Service Bulletin

No. : MZ07-053

Model: SR7400, SR8400

Subject: Software Update

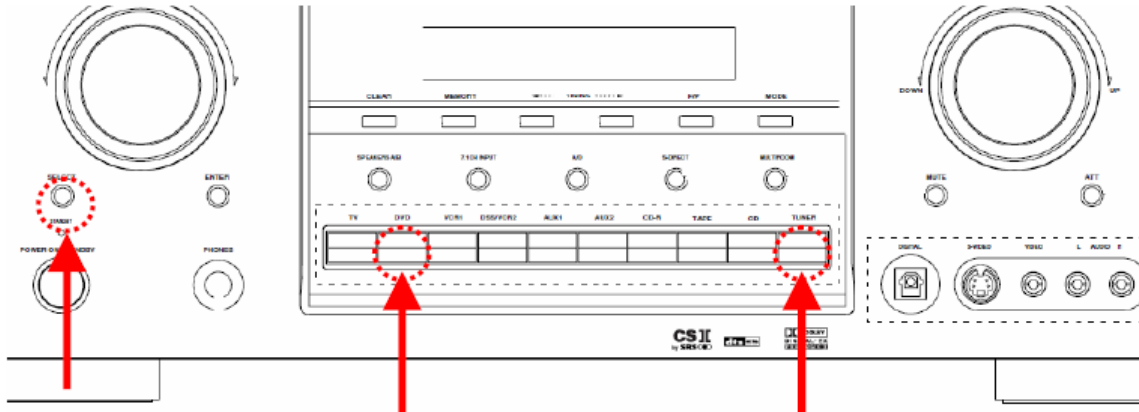
Originally, the unit was designed to go into STANDBY mode with the STANDBY LED flickering every 500m sec. upon detection of an abnormality. The unit would never be powered on by the standby switch or the remote control, so over dissipation never occurred. However, if the unit was unplugged and plugged in again, component over dissipation could occur before the unit went into standby a few seconds later.

The unit has been modified never to be powered on by any means once it goes into standby with the standby led flickering every 125m sec., unless a specialized procedure (*1 described below) is performed.

*1: If the unit cannot be powered on after being plugged in again (with the STANDBY LED flickering every 125m seconds), the power amp has failed. The unit still can be powered on again through the following method, but it can further damage the power amplifier. **Never let end-users perform this procedure.**

Can be powered on by “FACTORY KEY”=[PURE DIRECT]+[7.1 CH INPUT]+[CLEAR]
